**Minutes of the North Carolina Building Code Council  
September 1, 2020  
Raleigh, NC**

FIGURE R4603.6(d)  
CORNER PILE CONNECTION

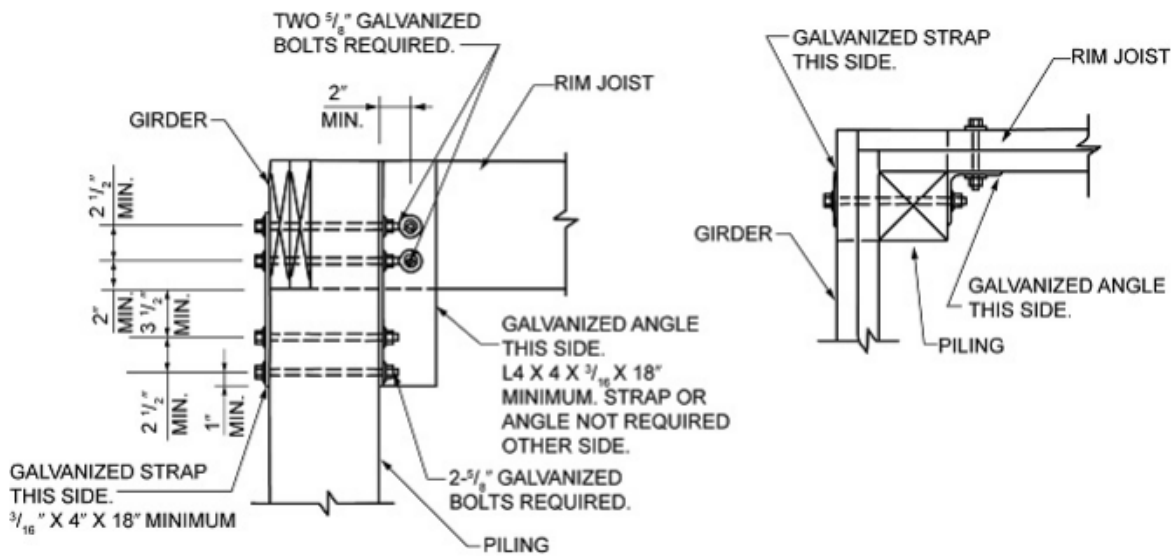
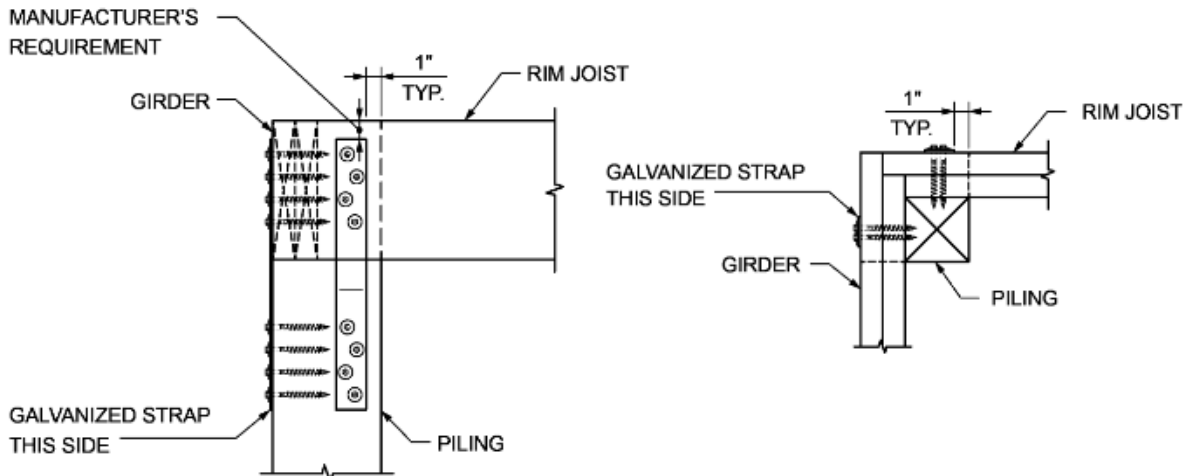
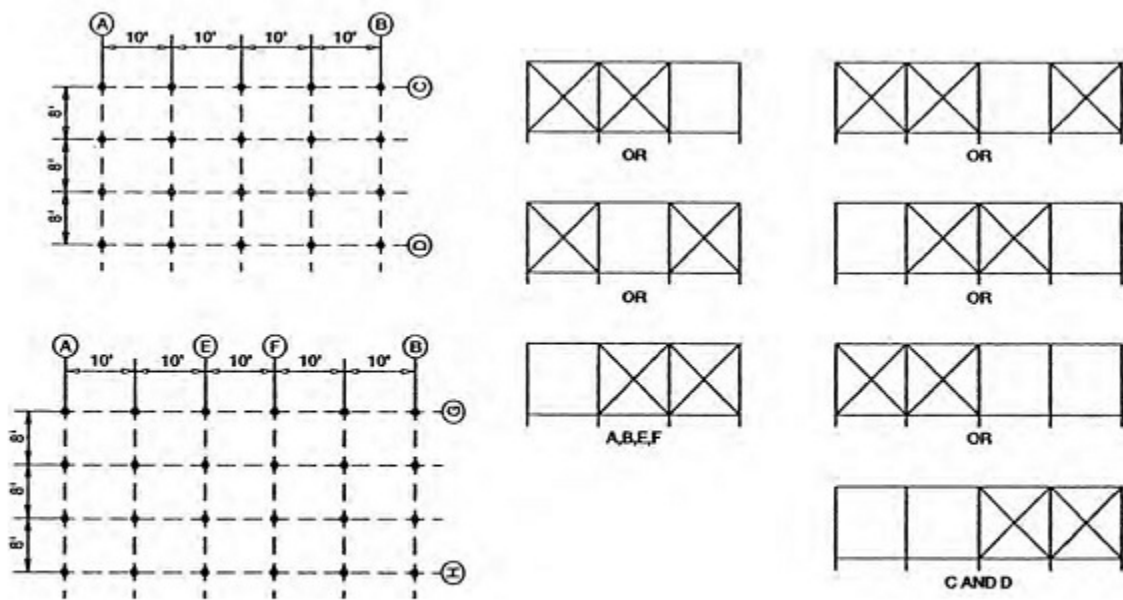
**R4603.6.1 Tying at corners.** At corners, girders shall be connected to the pile with a minimum 3/16 × 4 × 18-inch (5 × 102 × 467 mm) hot dip galvanized strap bolted with two 5/8 inch (15.9 mm) galvanized through bolts on the exterior and a minimum L4 x 3/16 x 1'-6" (102 × 5 × 467 mm) galvanized steel angle bolted with two 5/8 inch (15.9 mm) galvanized through bolts on the interior in accordance with Figure R4603.6(d1), or with a minimum of (2) 3/16" x 4" x 18" (5x102x467 mm) hot dip galvanized straps installed on the outside of the girders with fasteners per table R4603.6.1 and in accordance with Figure R4603.6 (d2).

**FIGURE AM105.2  
TYPICAL DECK GIRDER SPANS**

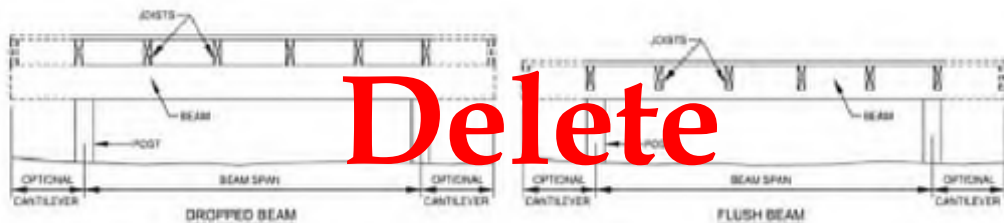
~~**AM105.2 Girder span for uncovered porches and decks.** Maximum allowable spans for wood deck girders, as shown in Figure AM105.2, shall be in accordance with Table AM105.2. Girder plies shall be fastened with two rows of 10d (3-inch × 0.128-inch) nails minimum at 16 inches (406 mm) on center along each edge. Girders shall be permitted to cantilever at each end up to one fourth of the actual beam span. Splices of multispan beams shall be located at interior post locations.~~

FIGURE AM106.1  
TYPICAL DECK JOIST SPANS

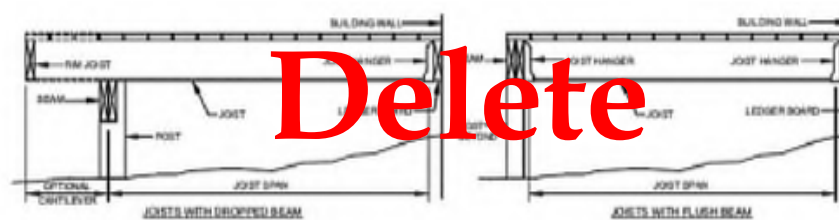
**AM106.1 Joist spans for uncovered porches and decks and cantilevers.** Joists spans shall be based upon Table R502.3.1(2) with 40lbs per sq ft of live load and 10 lbs per sq ft of dead load. Floor joists for exterior decks may be cantilevered per Table R502.3.3(1). Maximum allowable spans for wood deck joists, as shown in Figure AM106.1, shall be in accordance with Table AM106.1. Deck joists shall be permitted to cantilever not greater than one fourth of the actual, adjacent joist span.
